Access Compliance Report

Public Rights-of-Way

Intersection ID: 15070	Main Street: IDEAL_WY	Cross Street: REMOUNT_RD	Location: S
ADA ID: 7B5A127AE012	Ramp Type: Perp	Initial Pass/Fail: Fail	Overall Compliance: No
		Severity Score: 12.5

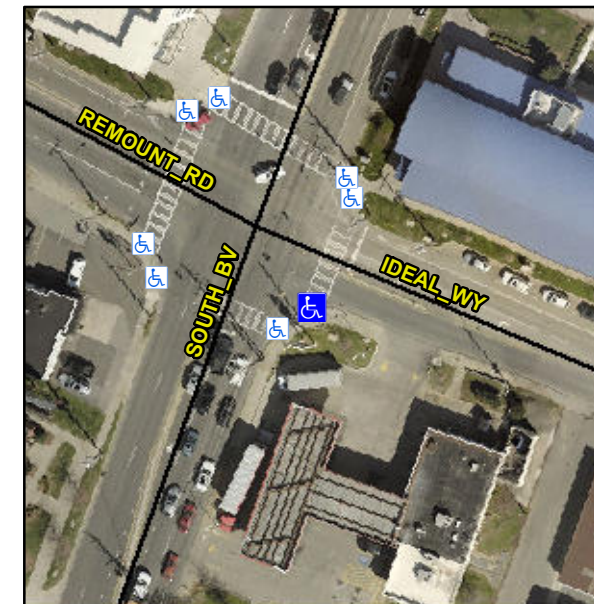
Not Found, R304.5.3

Compliance	Description	Data	Compliance	Description	Data
N/A	Ramp Length (in)	98.0	Yes	Ramp Slope (%)	6.2
Yes	Ramp Width (in)	48.0	No	Ramp XSlope (%)	6.3
N/A	Flare Type LT	N/A	N/A	Flare Type RT	N/A
N/A	Flare Slope LT (%)	N/A	N/A	Flare Slope RT (%)	N/A
N/A	Flare Traversable LT?	N/A	N/A	Flare Traversable RT?	N/A
N/A	Landing Length (in)	N/A	N/A	DWS Provided?	N/A
N/A	Landing Width (in)	N/A	N/A	DWS Contrast?	N/A
N/A	Landing Slope (%)	N/A	N/A	DWS Length (in)	N/A
N/A	Landing X Slope (%)	N/A	N/A	DWS Full Width?	N/A
N/A	Landing Curb? (Y/N)	N/A	N/A	DWS Offset (in)	N/A
N/A	Shared Landing?	N/A			
N/A	Gutter Ponding?	N/A	N/A	Gutter Slope (%)	N/A
N/A	Gutter Lip Ht (in)	N/A	N/A	Gutter X Slope (%)	N/A
N/A	Painted X Walk1?	Yes	N/A	Painted X Walk2?	N/A
	X Walk 1 Direction	To NE		X Walk 2 Direction	N/A
N/A	X Walk 1 Width (in)	112.0	N/A	X Walk 2 Width (in)	N/A
	X Walk 1 Slope (%)	3.6		X Walk 2 Slope (%)	N/A
	X Walk 1 X Slope (%)	8.5		X Walk 2 X Slope (%)	N/A

Remove & Replace Entire Ramp.
